Proposed Residential Development,
Water Rock, Midleton

Road Safety Audit Stage 1

Client	Haven Falls Ltd.
Project Title	Residential Development
Project Location	Water Rock, Midleton, Co. Cork
Document Title	Road Safety Audit Stage 1
Document No.	MHL-21154TT-WATER ROCK MIDLETON-DOC03-RSA
Job No.	21154TT

2.3 PROBLEM 3: LACK OF ROAD SIGNAGE

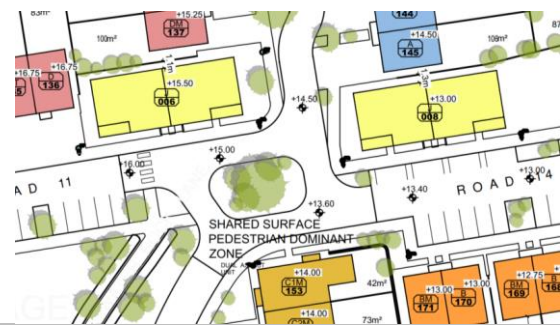
No junction stops signs are shown junction within the development. Failure to provide appropriate road signage may cause confusion with regard to priority at the entrance junction, leading to collisions between passing vehicles and vehicles exiting the development.

Provide adequate signing at all junctions, in accordance with the relevant standards. A combined 30km/h speed limit and warning signage in accordance with circular letter PL/6 2014 should be provided within the development.
